SEWAGE DISPOSAL SYSTEM

MARYLAND STATE DEPARTMENT OF HEALTH

HOWARD COUNTY

A SEWAGE DISPOSAL SYSTEM LOCATED AT Daisy Road about 2 9/10 miles from Rt. 114 on right
red flag on mailbox about 2/10 mi. past Daisy Church

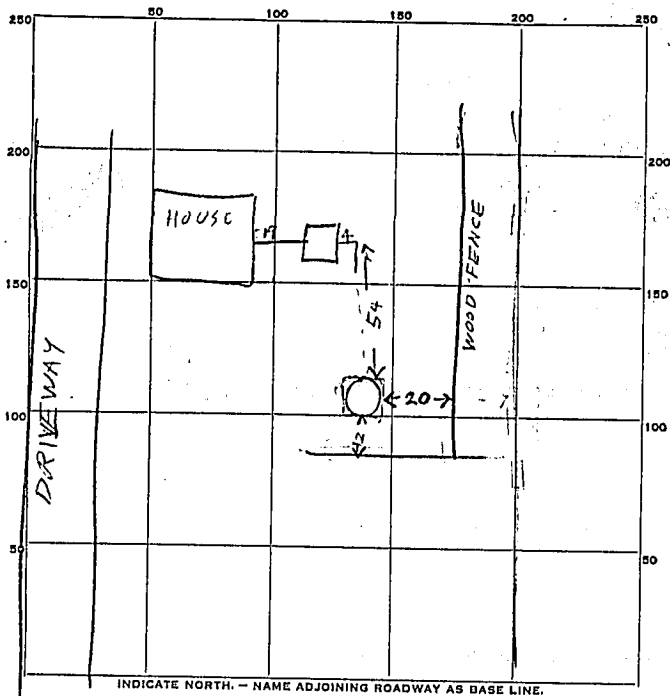
REMARKS Dry Well: 10' deep below top. Inlet pipe not installed. Top not finished. More stone needed between dirt wall & under block. System will be OK if these things are finished. Tank can be covered.

5/27/63. owner states this system was completed & is satisfied except for cleanout pipe not being installed. DWY

OTHER Dry Well - One Dry Well 10 ft. diameter and 10 ft. deep below the inlet
pipe. Inlet pipe to be 3 ft. below original grade. Place dry well in area that
passed percolation test.
